AGENDA

PLANNING AND ZONING COMMISSION WORK SESSION MEETING
CITY HALL, 385 SOUTH GOLIAD STREET, ROCKWALL, TEXAS
DECEMBER 27, 2023 IN THE CITY COUNCIL CHAMBERS AT 6:00 PM

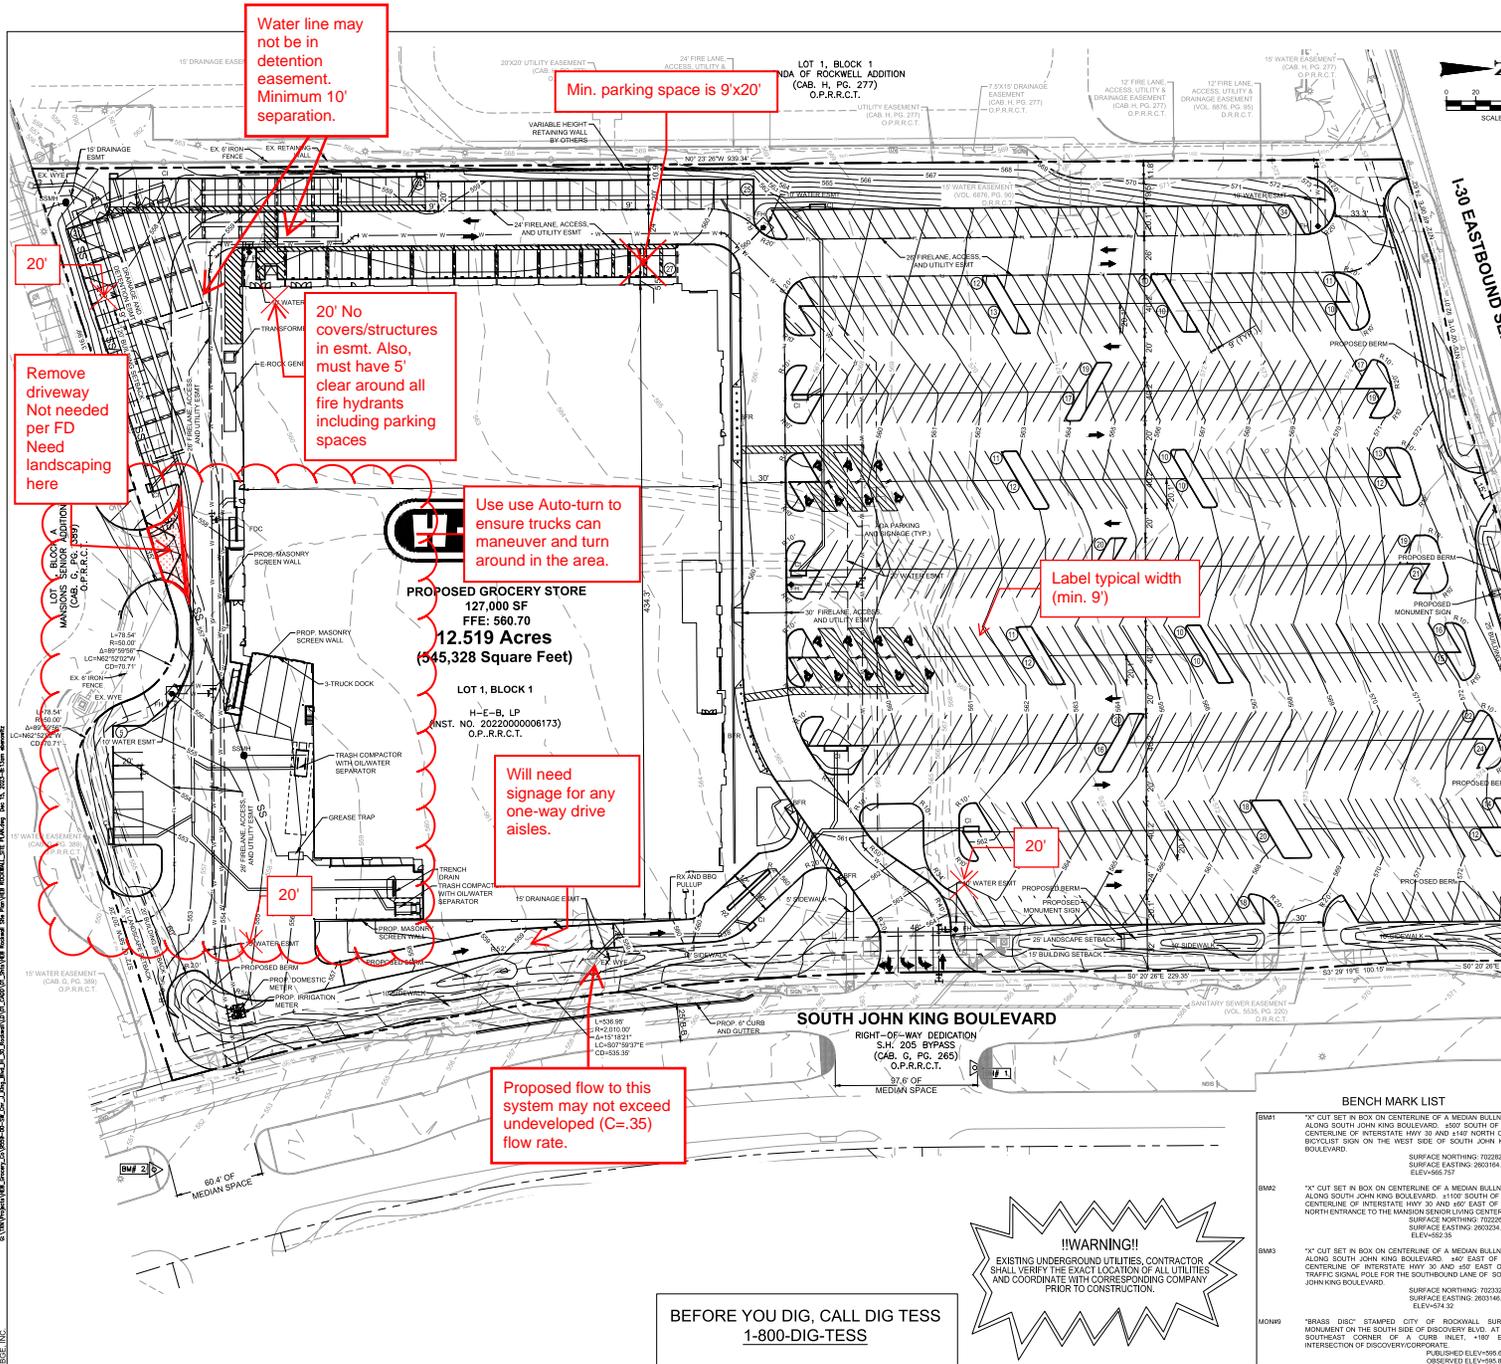
GIS COMMENTS:

PARKS DEPARTMENT COMMENTS:

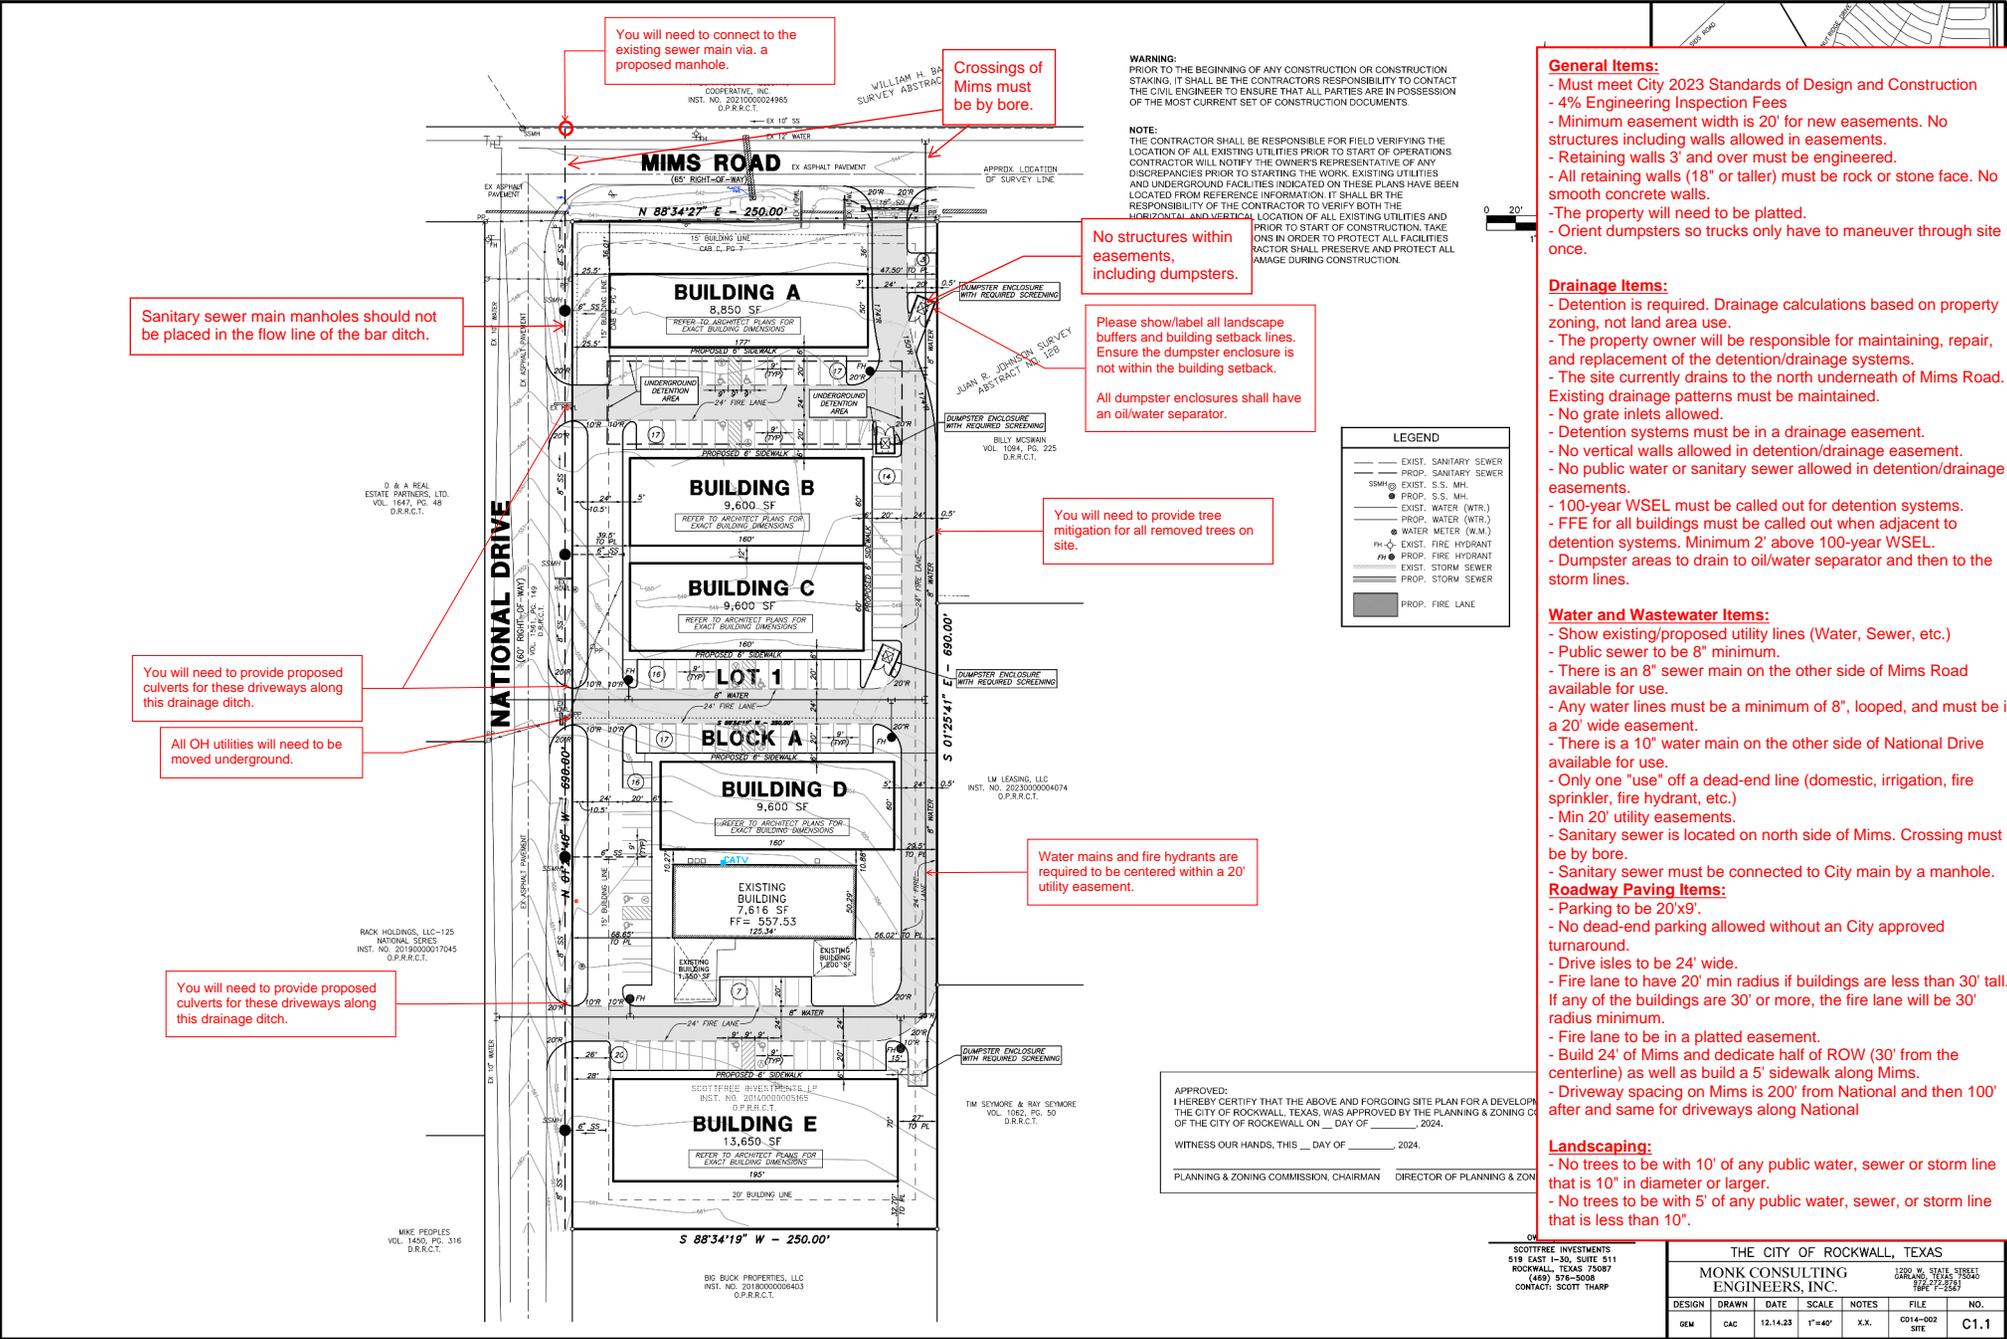
GIS COMMENTS:
